**No. EC120-53A015**

# ALERT SERVICE BULLETIN

### FUSELAGE - TAIL BOOM

#### Corrosion on the tail boom

Figure 1

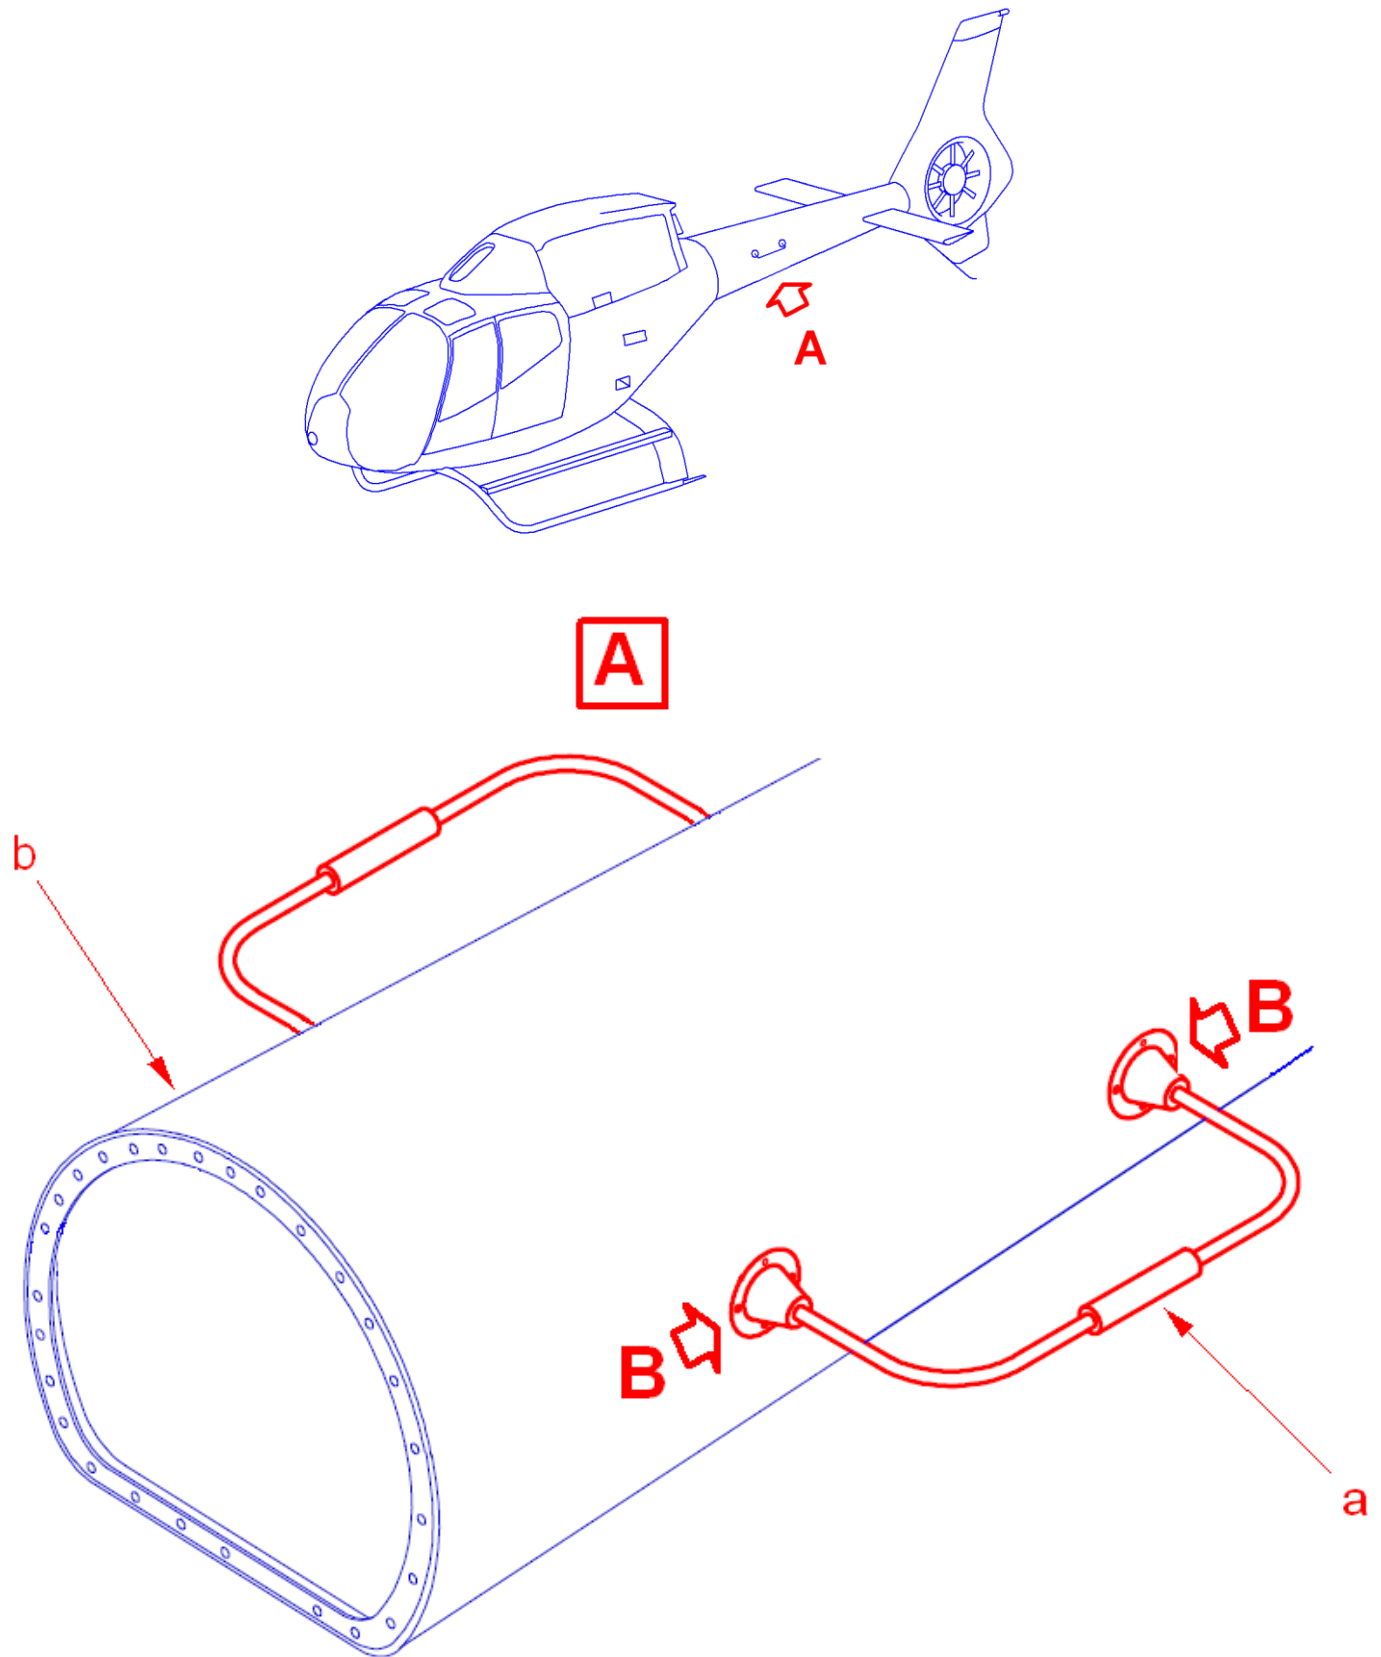
##### 3.B.2.a. Check for corrosion and cracks under the LH VOR antenna mounting bases or blanks (Figure 1)

- Remove the antennas (a), if installed, or the blanks installed in place of the VOR antennas, as per AMM Task 34-55-02, 4-1 (Figure 1).
- Clean the areas (b).
- Make sure that:
  - . there is no aluminum oxide (white powder) on the VOR antenna attachment screws (c), on the skin and at the screw holes (d).
  - . that there are no cracks on the skin at the VOR antenna attachment screw holes (d). If in doubt, carry out a dye-penetrant inspection as per AMM Task 20-10-00, 3-19.

Figure 2

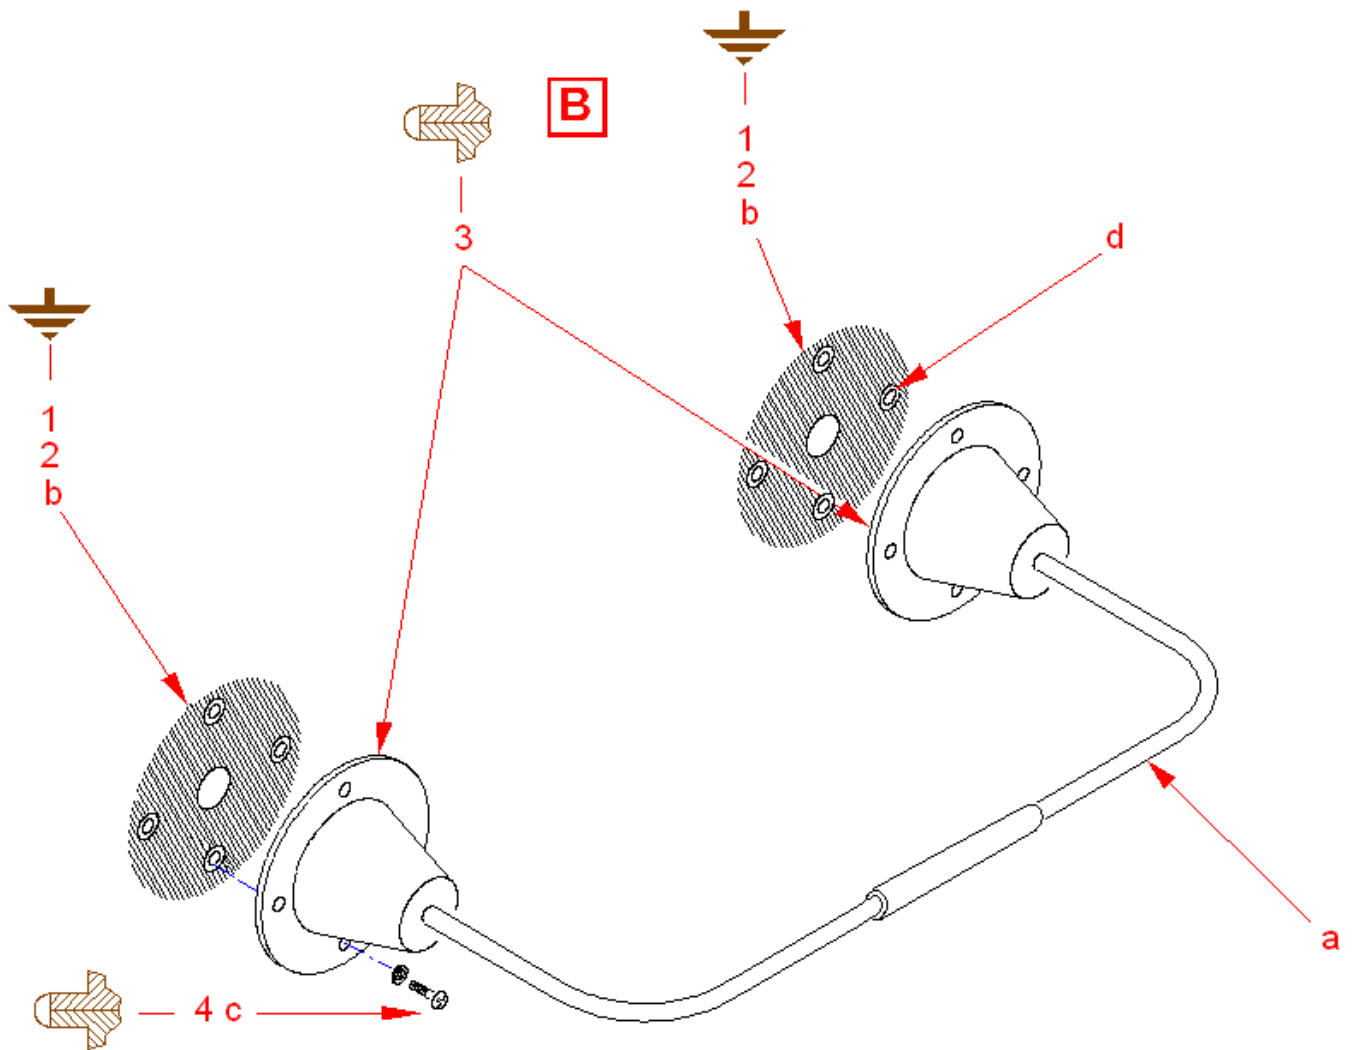
##### 3.B.2.b. Embodiment of MOD C008A0345065 (Figure 2)

- Strip the areas (b) on the tail boom skin in accordance with the method given in AMM Task 20-10-00, 3-4.
- Touch up the areas (b) using ALODINE 1200 (1) as per AMM Task 20-10-00, 3-7.
- Apply conducting paste (2) to the areas (b).
- Reinstall the antennas (a), if installed, or the blanks installed in place of the VOR antennas, as per AMM Task 34-55-02, 4-1.
- Apply a bead of sealant (3) around the antenna mounting bases or blanks as per AMM Task 20-10-00, 3-14.
- Apply sealing compound (4) to the screw heads (c) as per AMM Task 20-10-00, 3-14.

Figure 3 (Examples of corrosion)

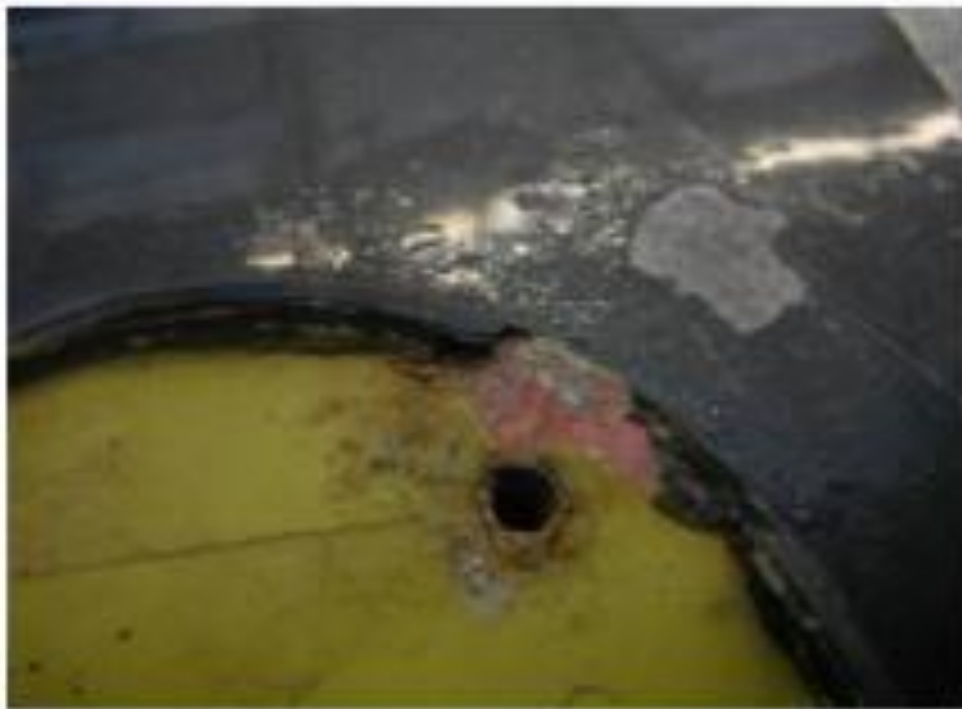
Corrosion and cracks were found on the external tail boom skin, at the attachments of the LH and RH VOR antennas (Figures 3 and 4).

This galvanic type corrosion is due to:

- contact between the aluminum skin and the stainless steel antenna attachment inserts,
- a lack of protection.

##### 3.B.2.a.1. Presence of corrosion and/or cracks (Figures 3 and 4)

- Contact Airbus Helicopters at the following address:
  - Tel.: + 33 (0)4.42.85.97.89
  - Fax: + 33 (0)4.42.85.99.66
  - E-mail: [Airframe.Technical-Support@airbus.com](mailto:Airframe.Technical-Support@airbus.com)

And comply with Service Bulletin No. 53-016.
